Attachment

Unit 1

Page 3/4 4-28
Page 3/4 4-29
Page 3/4 4-30
Page B3/4 4-7
Page B3/4 4-8
Page B3/4 4-9

FARLEY-UNIT 1

Figure 3.4-3 Farley Unit 1 Reactor Coolant System Cooldown Limitations
 Applicable For The First 7 EFPY

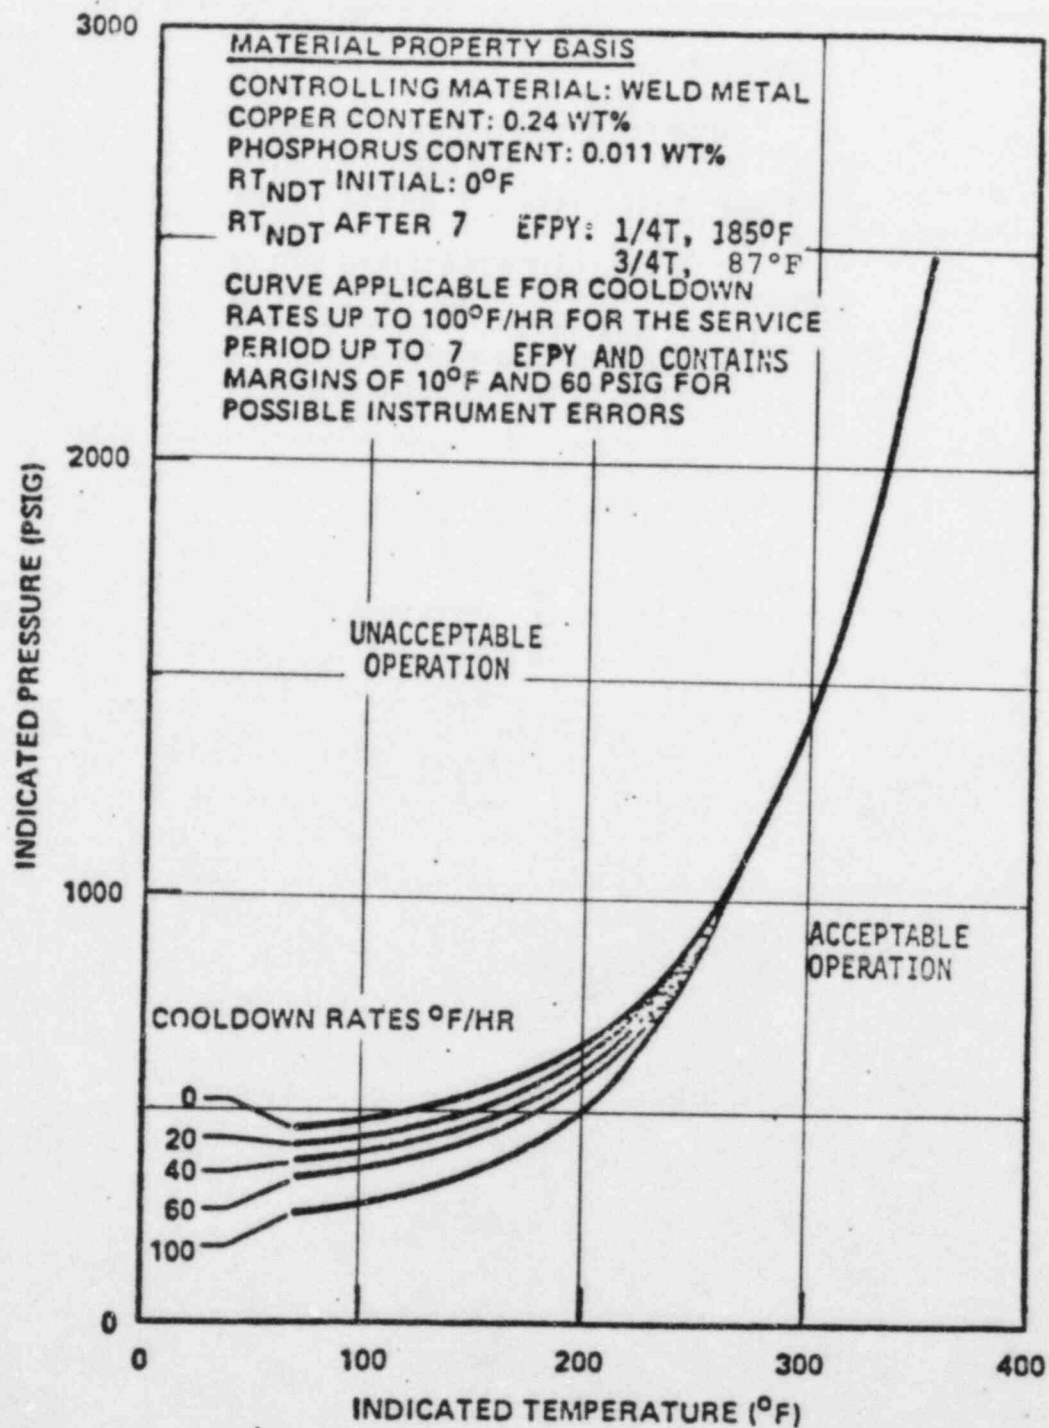
Heatup and cooldown limit curves are calculated using the most limiting value of the nil-ductility reference temperature, RT_{ndt} , at the end of 7 effective full power years of service life. The 7 EFPY service life period is chosen such that the limiting RT_{ndt} at the 1/4T location in the core region is greater than the RT_{ndt} of the limiting unirradiated material. The selection of such a limiting RT_{ndt} assures that all components in the Reactor Coolant System will be operated conservatively in accordance with applicable Code requirements.
